Gloucestershire Ramblers Area

A417 NH DCO Barrow Wake -

Re: A417 Missing Link at the Air Balloon National Highways Application for a Development Consent Order

Adverse Impact of the scheme on Barrow Wake View point, Car park and SSSI

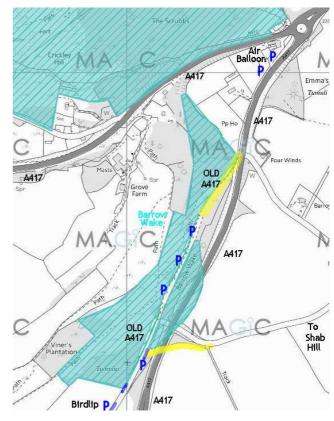
The Magic Map right highlights, in light blue, the Areas designated in 1986 as a Site of Special Scientific Interest.

It was assumed that the old A417 would continue to pass between the two pieces of Barrow Wake SSSI with roadside parking for the views. (Yellow shows the old road to the Air Balloon and old minor road to Shab Hill.)

However updates to the A417 were approved at the same time, apparently without knowing about the SSSI. Hence the location of the current A417 (grey) and underpass (white) to Shab Hill within the SSSI boundary.

Biodiversity Net Gain

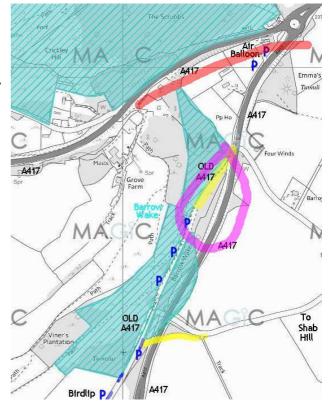
The current proposals pass the new A417 (red) through a deep cutting, removing the northerly tip of the Barrow Wake SSSI. Taking the road underneath would need less excavation and avoid seeking so much mitigation in the scheme. It may be possible to extend the SSSI there too.

Some spare ground (circled mauve) between the old and current A417 might also be useful for the SSSI although the old road itself (vellow) should be retained for at least foot access to the viewpoint car park, or perhaps one way traffic.
